**EC TITLE:** Facility 400 Encasement Detail Modification  
**PROJECT:** 3 Kings Water Treatment Plant

**EC NO.:** 36  
**DATE:** 7/13/2020  
**STATUS:** Acknowledged

**DRAWING NO.:** 400-S-5002 STRUCTURAL - FACILITY 400 -  
DISINFECTION AND PUMPING - DETAILS

**6** VERTICAL PIPE ENCASEMENT  
3/4"=1'-0"  
400-S-2001  
400-S-2002  
400-S-3002

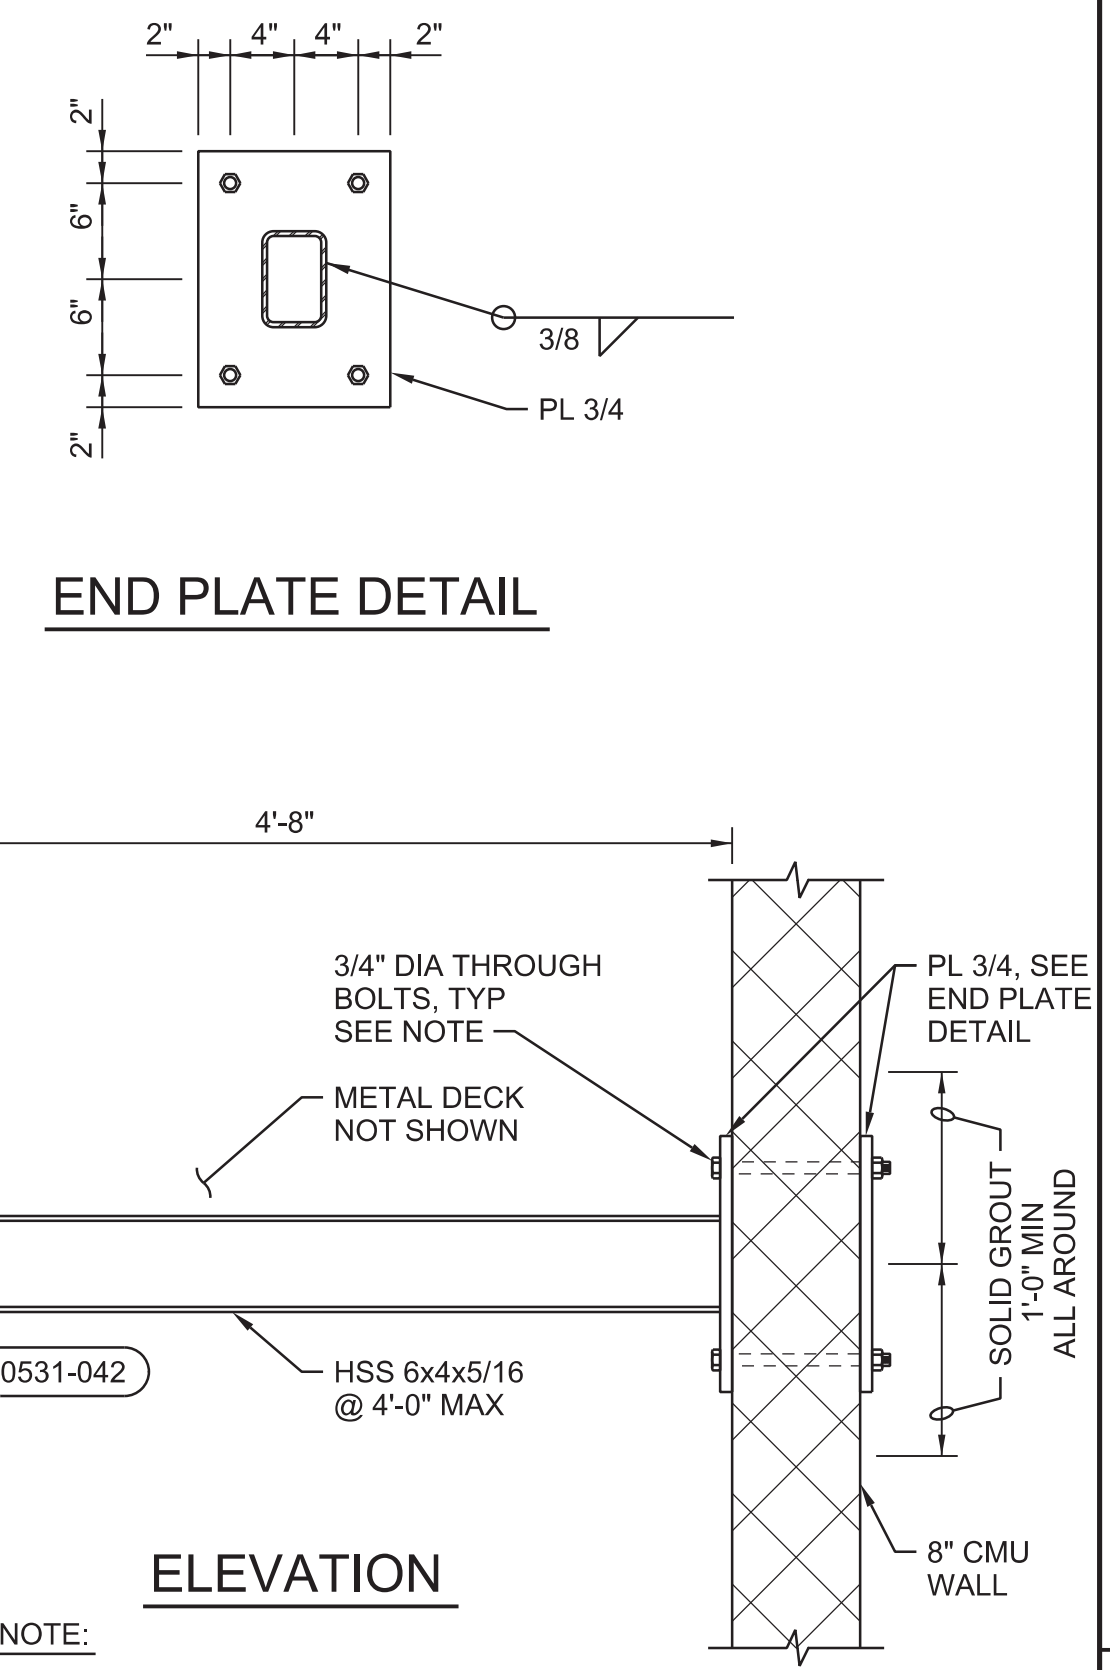
Detail 6 on Construction Drawing 400-S-5002 showed an encasement width of DIA+8". This has been adjusted to show DIA/2 + 8".

See response to RFI 80 as well as corrections to Detail 6 on Construction Drawing 400-S-5002.
